OVERLOT GRADING, POND SR4 & UTILITY CONSTRUCTION DOCUMENTS

FALCON MARKETPLACE

Approved with conditions as noted above**
by Elizabeth Niekamp
El Paso County Planning and Community Development
on behalf of Jennifer Irvine, County Engineer, ECM Administrator
10/10/2018 3:30:30 PM

OPEN CHANNEL ALONG E. WOODMEN ROAD

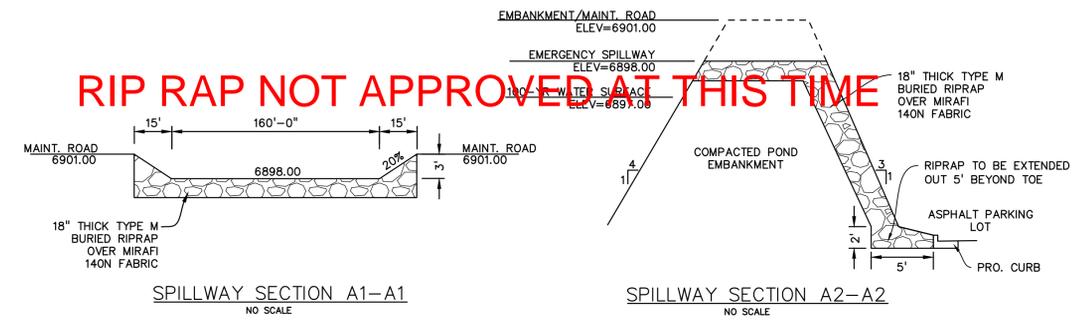
3. The riprap spillways proposed for Pond SR4 construction are not approved at this time. Provide an analysis for the use of riprap, geocellular products and articulated concrete block products. Written notification from PCD staff is required prior to installation of the spillway protection.

RIP RAP NOT APPROVED AT THIS TIME

SUB-REGIONAL POND #1 (SR4)

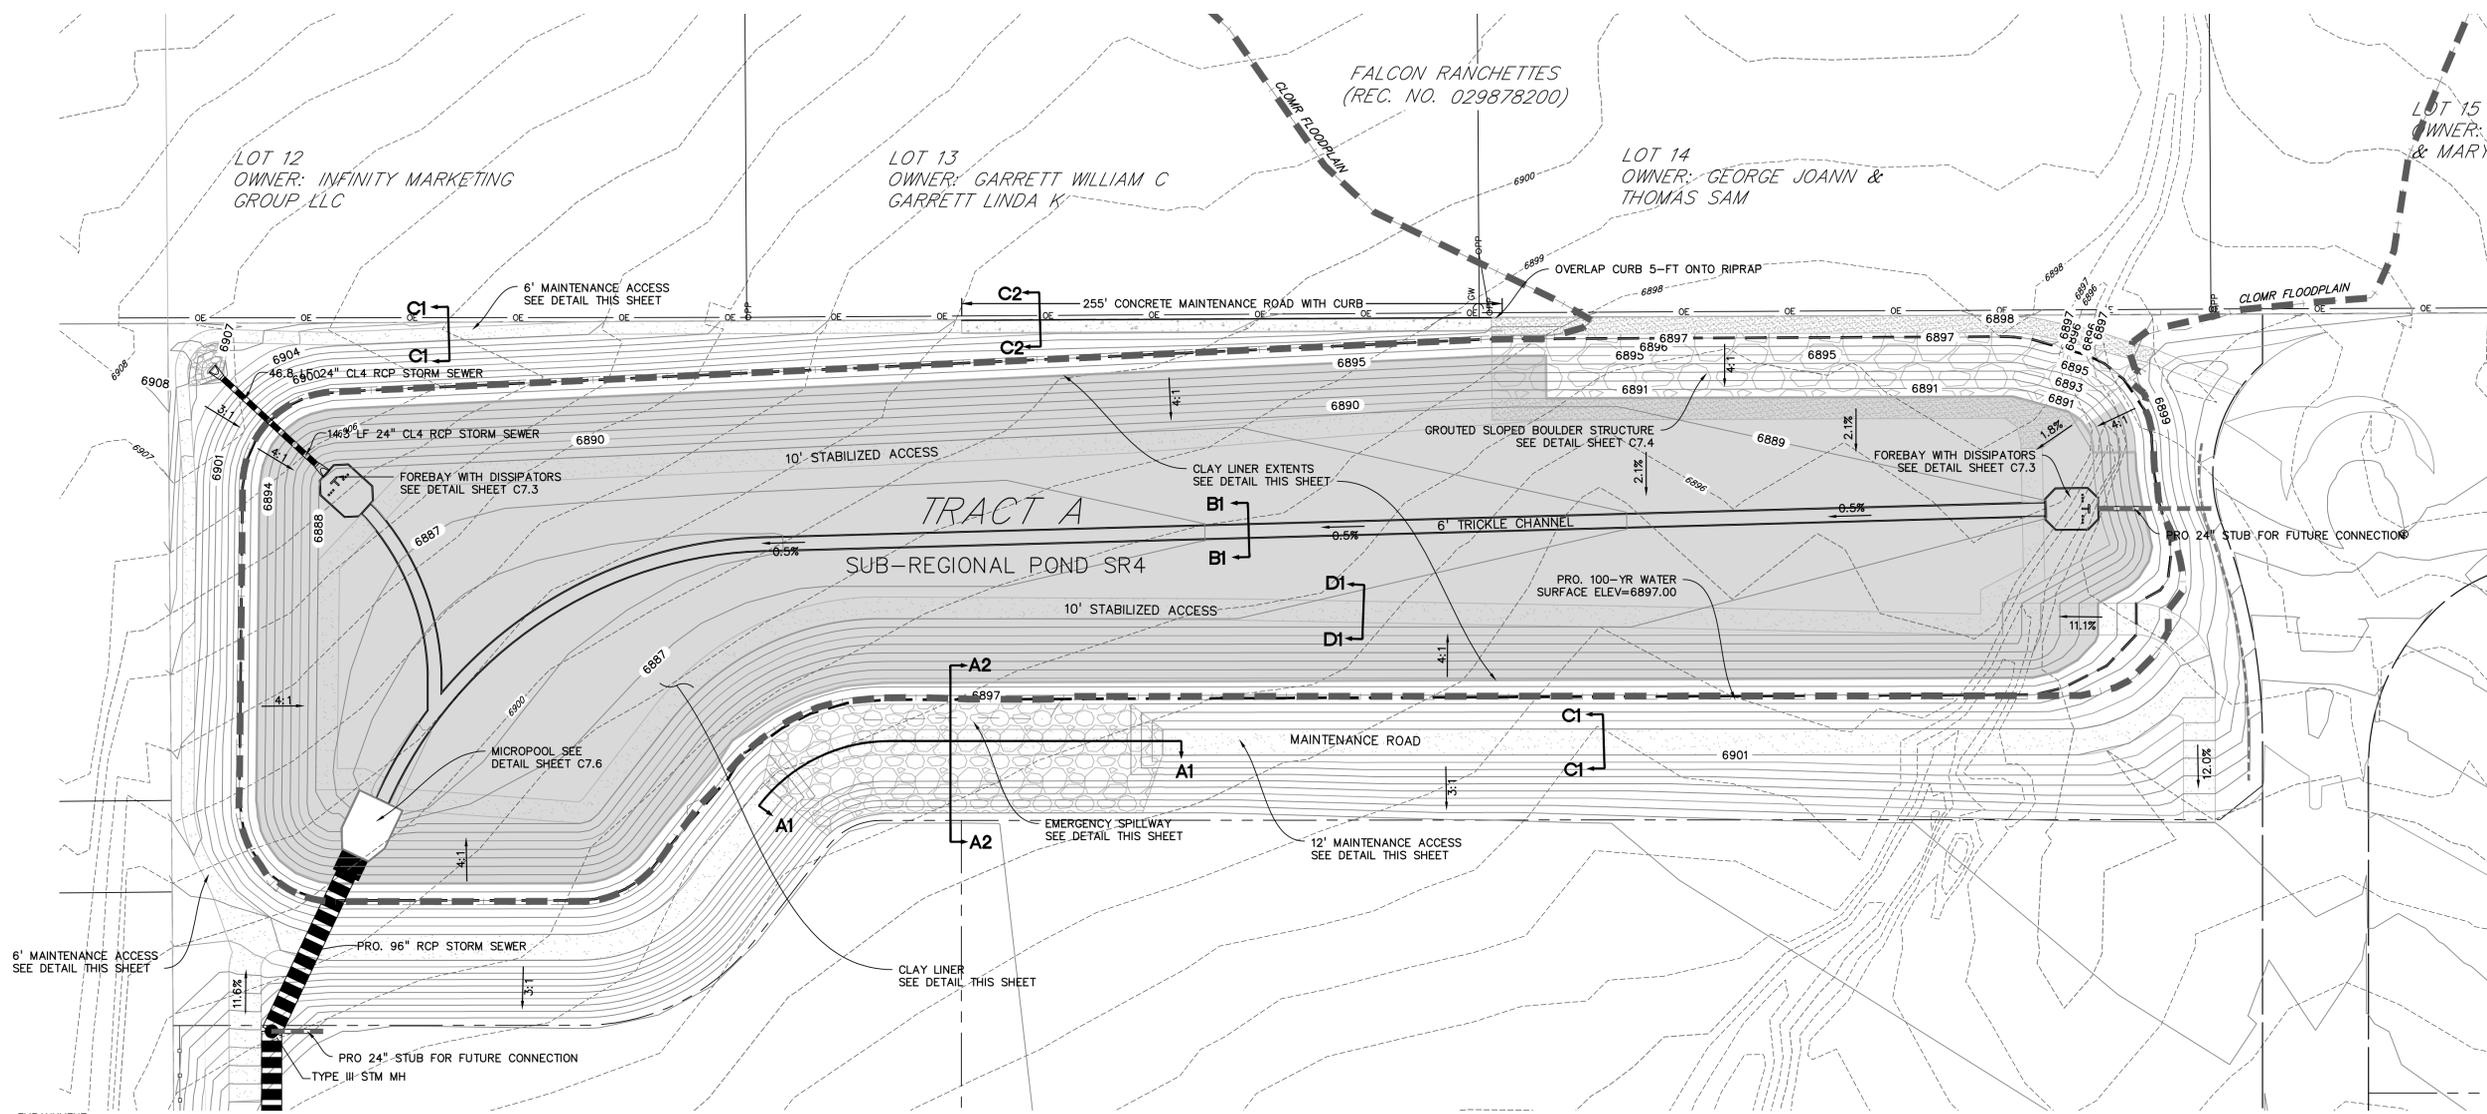
2. The clay liner proposed for Pond SR4 construction is not approved at this time. Provide rationale that other impermeable lining methods are not practicable, including rubber lining. Placement of any liner requires separate written approval after PCD staff receipt of this additional information as well as project-specific liner specifications, signed and stamped by a Colorado PE.

CLAY LINER NOT APPROVED AT THIS TIME
